## PCI-SIG ENGINEERING CHANGE NOTICE

<b>TITLE:</b>	PERST# Clarification
<b>DATE:</b>	November 26, 2003
<b>AFFECTED DOCUMENT:</b>	PCI Express Card Electromechanical Specification, Revision 1.0a
<b>SPONSOR:</b>	Chuck Stancil; Hewlett-Packard

Figure 2-4a: Out-of-tolerance threshold windows

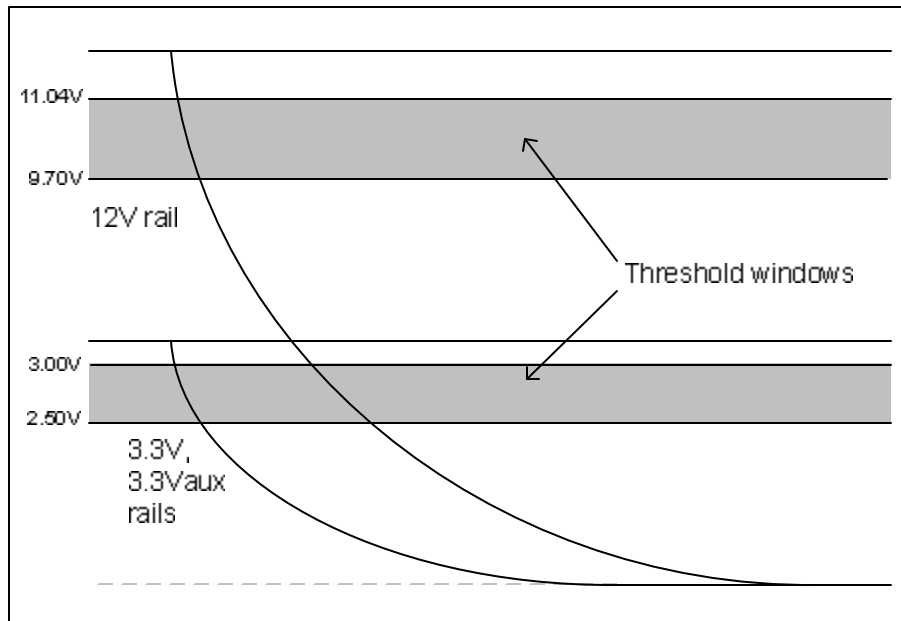
A power rail (12V, 3.3V or 3.3Vaux) is deemed to be valid or stable if the specified voltage is within the associated voltage tolerances defined in Table 4-1. Once a power rail is deemed stable, an invalid or unstable rail is defined as a rail that has dropped below the specified minimum voltage levels (e.g. below 3.00V for the 3.3V rails). For purposes of detecting an out-of-tolerance power source, the threshold for detection should be established in a window range of no more than 500mV below the specified minimum voltage level for the 3.3V and 3.3Vaux rails (i.e. 2.50V) and 1.34V below for the 12V rail (i.e. 9.70V). Figure 2-4a illustrates these threshold windows.

Insert the following figure and caption below the new text for section 2.2.3 and before the existing Figure 2-4.
